**ARCHITECTURAL REVIEW BOARD
MUNICIPAL PLANNING COMMISSION
-AGENDA-
Thursday, October 26, 2023 at 7:00 P.M.**

MEMORANDUM

SUBJECT: Staff Memo for the Meeting of October 26, 2023

Michelle Wadsworth
Site plan
334 East Dublin Granville Road
Columbus, Ohio 43085

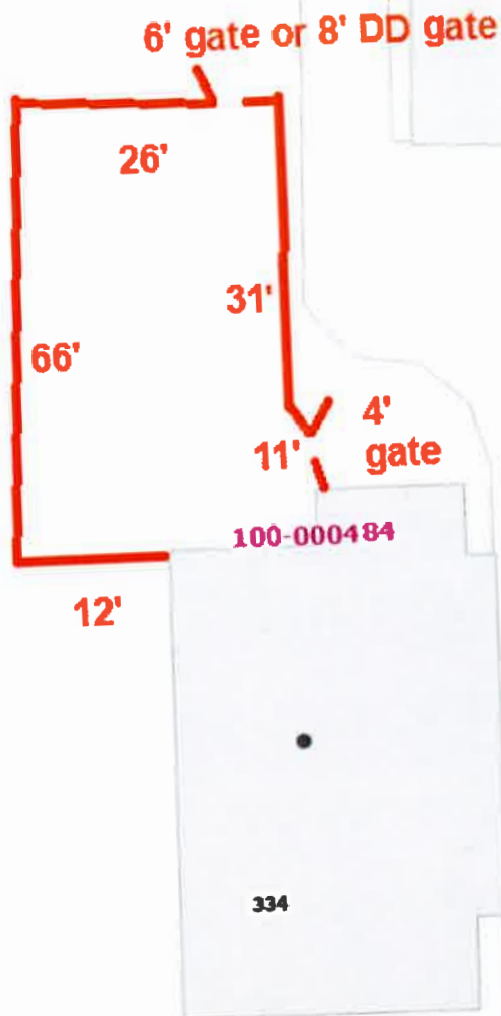
1. The fence is planned to connect to the northwest corner of the house; extend west approximately 12'; and then go north 66'; and then go east 26' to the concrete pad adjacent to the garage which would include a 6' or 8' wide gate. The fence will then come 46' south to connect with the existing house which would include a 4' gate near the rear entrance to the home.
2. The proposed fence appears to be 5' to 6' off the property line according to the site plan.
3. The fence would be black aluminum and 4' in height.

Staff is recommending approval of this application as the fence is similar in style to other fences approved by the Board throughout the Architectural Review District.

FIRST FLOOR PLAN - Proposed

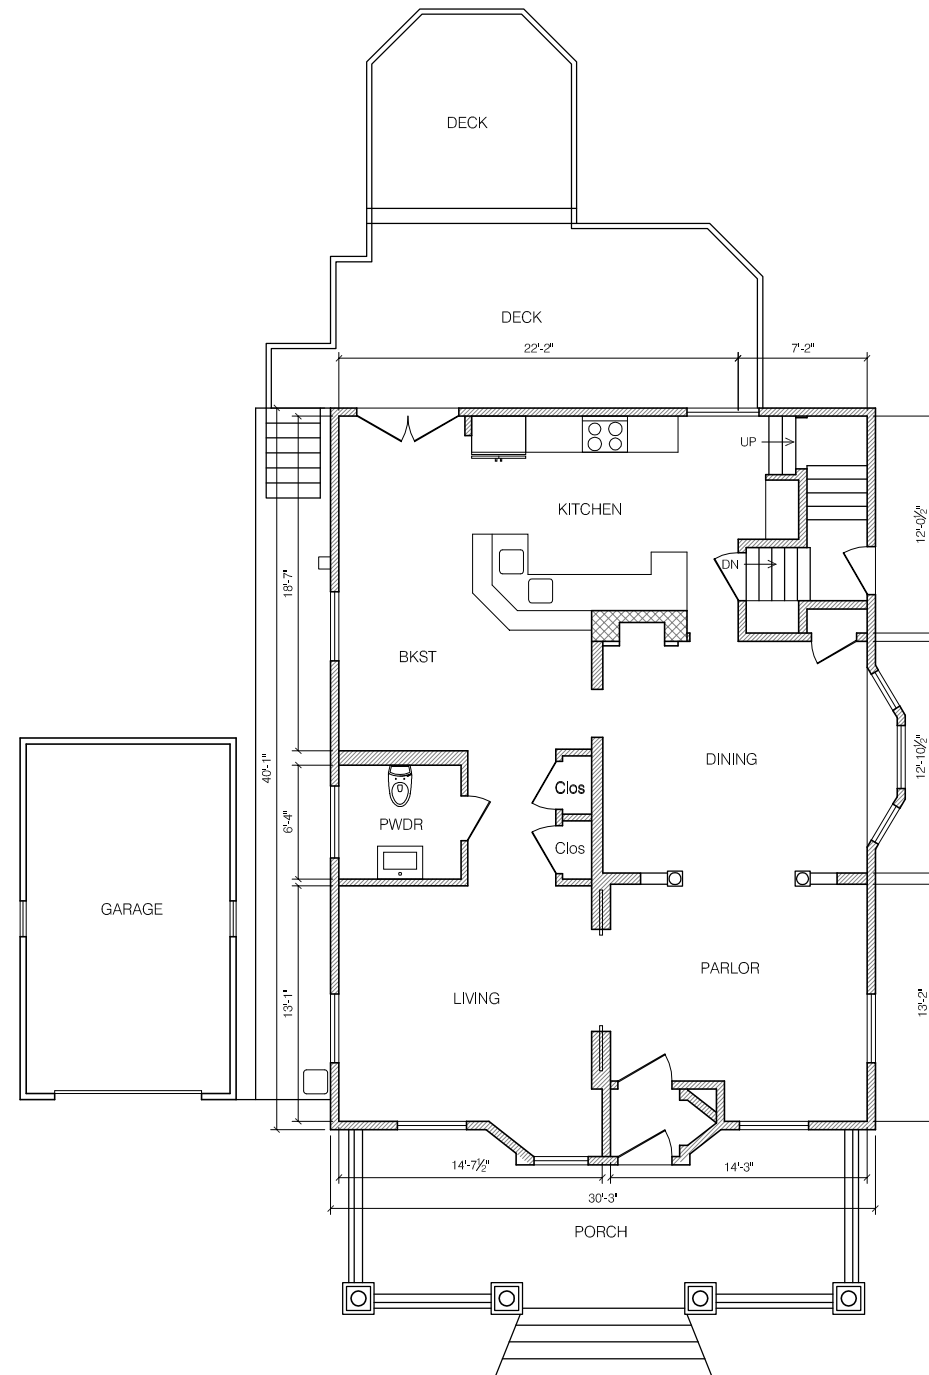
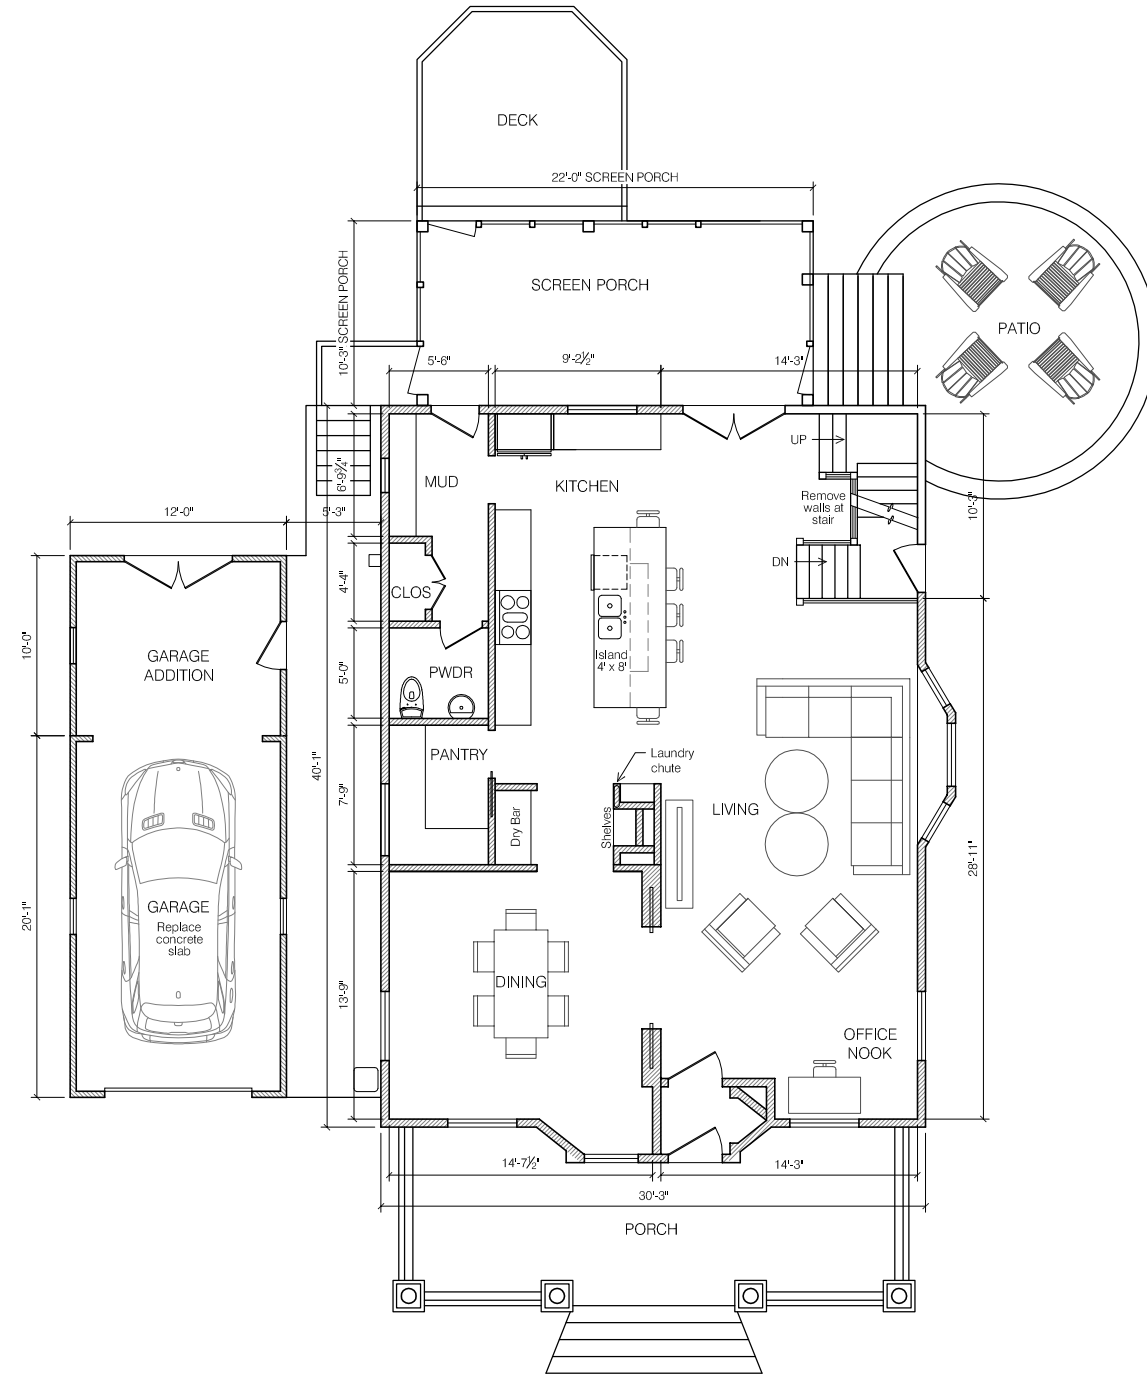
- d. It appears that an existing patio door will be removed and replaced with a single door and there will be an additional patio door added to the screened porch to replace an existing window.

BASEMENT FLOOR PLAN -
Proposed

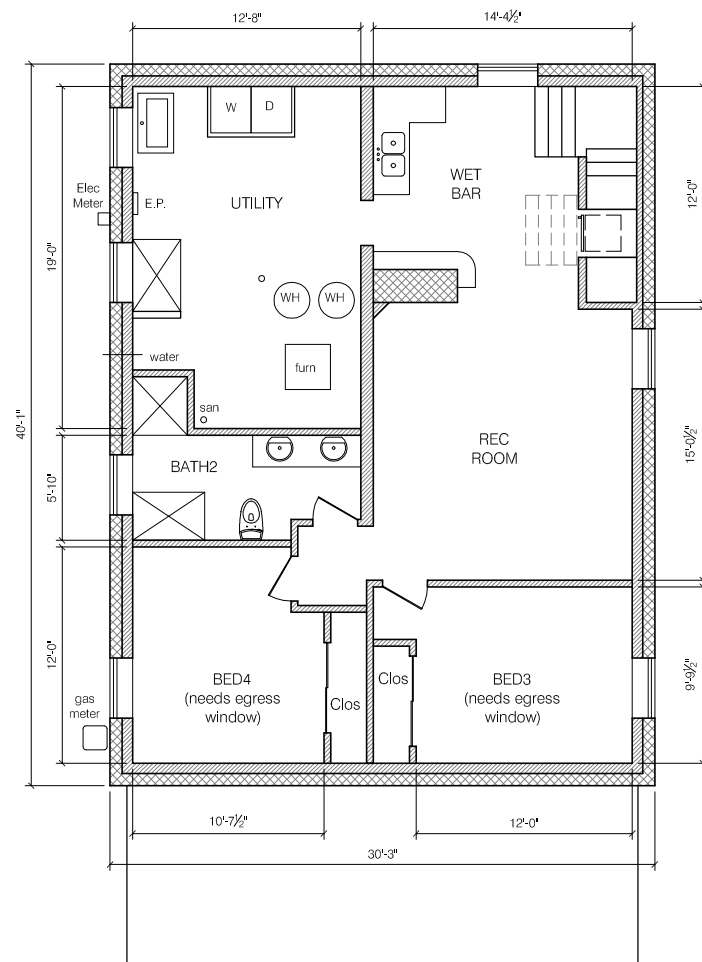
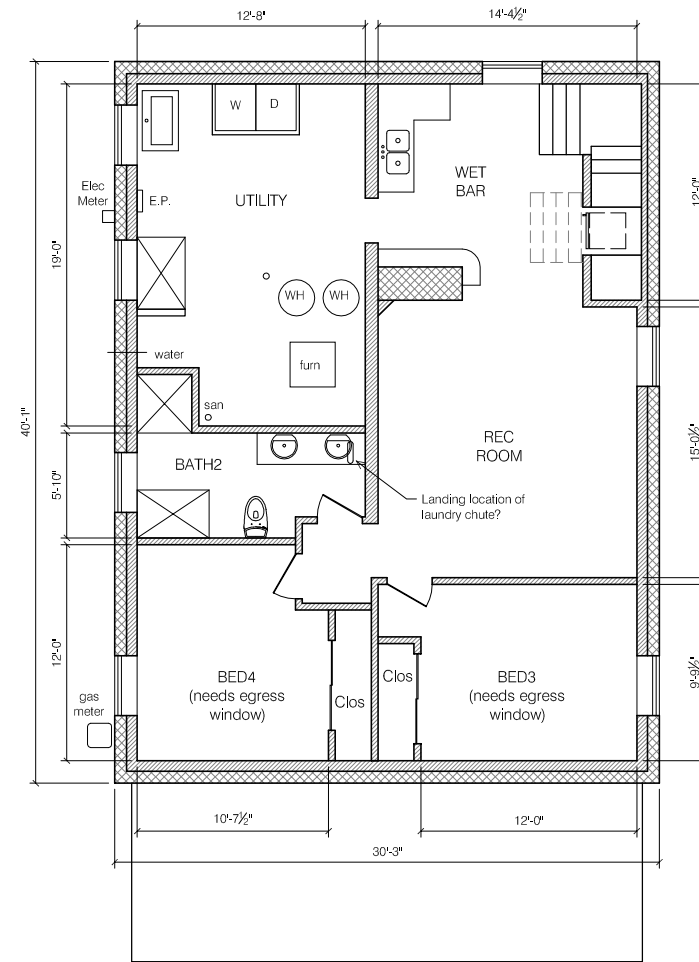
- d. Basement egress windows are shown on the floor plans; however, the elevations do not reflect this change.
 - i. No information was provided.
 - 1. Clarification is needed.

SITE PLAN

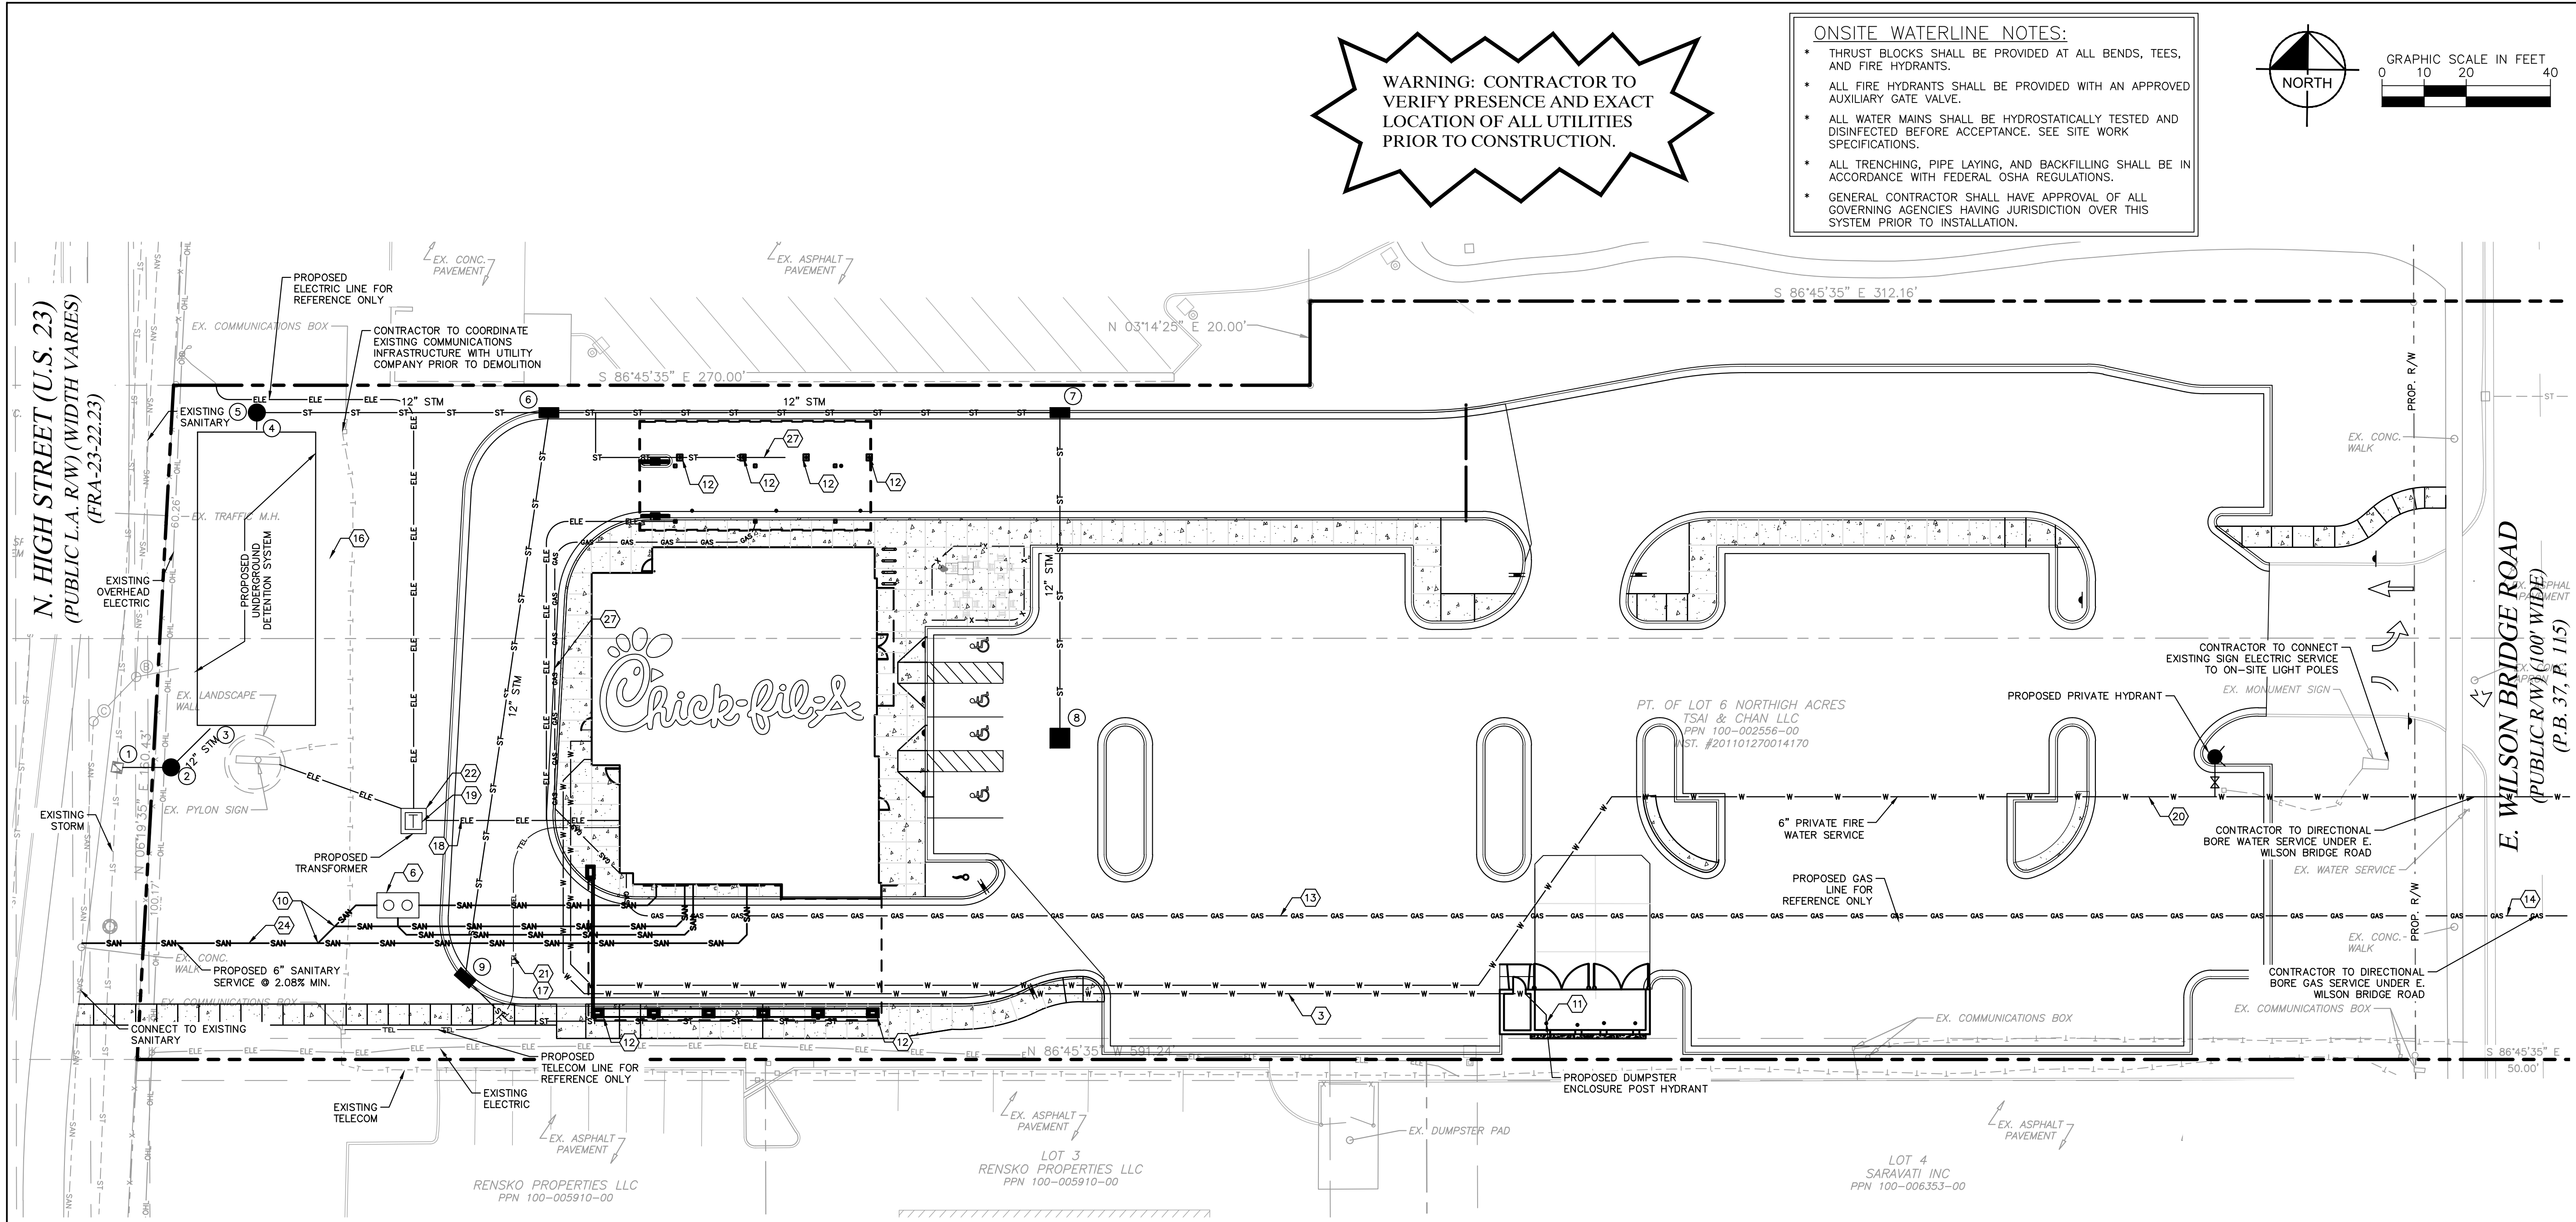
- The revised plans show a sidewalk along the southern portion of the site extending out to N. High St.
 - This portion of N. High St. is limited in access and sidewalks directly to the N. High St. public right-of-way is not permitted.

- The site plan needs to be updated.
- e. Outdoor Seating Area:
 - Four tables with red umbrellas are shown east of the north end of the building in front of the main entrance. Logos would not be permitted on the umbrellas.

- The applicant plans to install an underground detention system in the area north of the sign near the N. High St. right-of-way.
 - A variance would be needed for the location within the 100' setback.
- City staff has requested the underground detention system be moved in case this area would need to be utilized in the future to provide access to the parcels fronting N. High St. by an access drive in the future if curb cuts along E. Wilson Bridge Rd. are restricted to a right-in/right-out only movement with a divided median along E. Wilson Bridge Rd.
 - There are no plans at this time, however placement of infrastructure in the setback should be limited.
 - Staff is not requesting an access easement at this time, however if needed in the future the City would expect the applicant to work with the City.

- b. A simplified site plan with structures and dimensions to property lines is needed to determine what structures are in the required setbacks.
- c. Pedestrian access from the parking lot to the front door might be difficult as parking, seating and bicycles could be barriers.
